ISIS practice
For Openreach People & Partners

AEI/AEC/B361

Obsolete Dropwires

Change to renewal policy

For Pole renewal work only

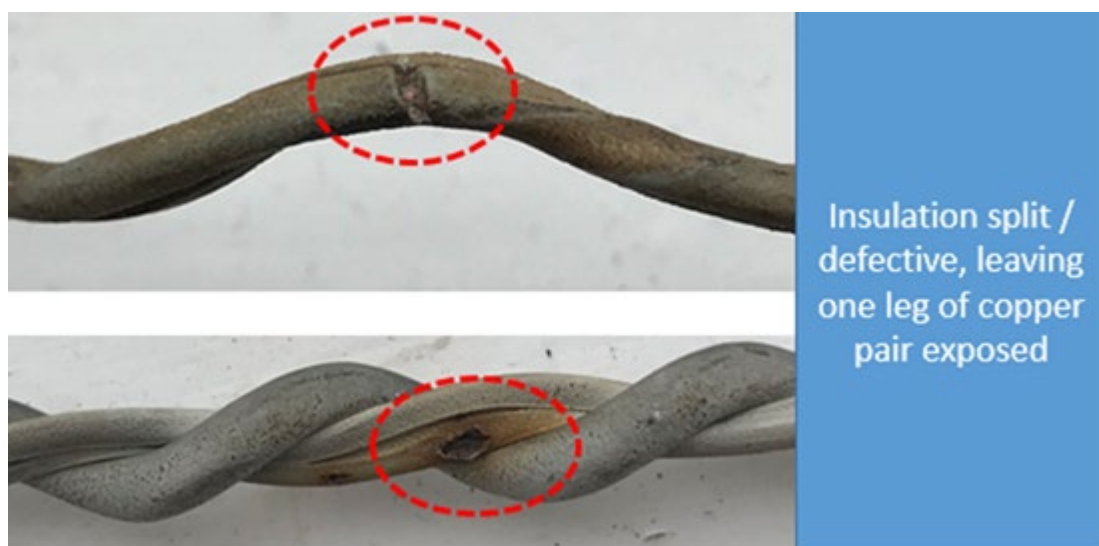
- The re-hanging of obsolete type Dropwires is now permitted, provided that the insulation is not *damaged / defective
- Where a wire is found to be *damaged or defective, or is made so by unwinding / re-winding the Dropwire onto the clamp, then renewal of the Dropwire span is required. The exception would be where the Customer has

- Up to 2 x Joints in the Dropwire are permitted between the final Pole and the premises. These are to be housed in an Above Ground Closure, which at the pole end should be attached to the clamp using 2 x Straps Cable Fixing 12a
- The obsolete wire must not be run directly into a Box Conn 20. It must be extended (pieced out) to the tool-less modules within the block, using a 0.5mm tail and Connector Dropwire 2A

*Examples of damage / defective are shown below. These are intended as a guide and are not exhaustive.
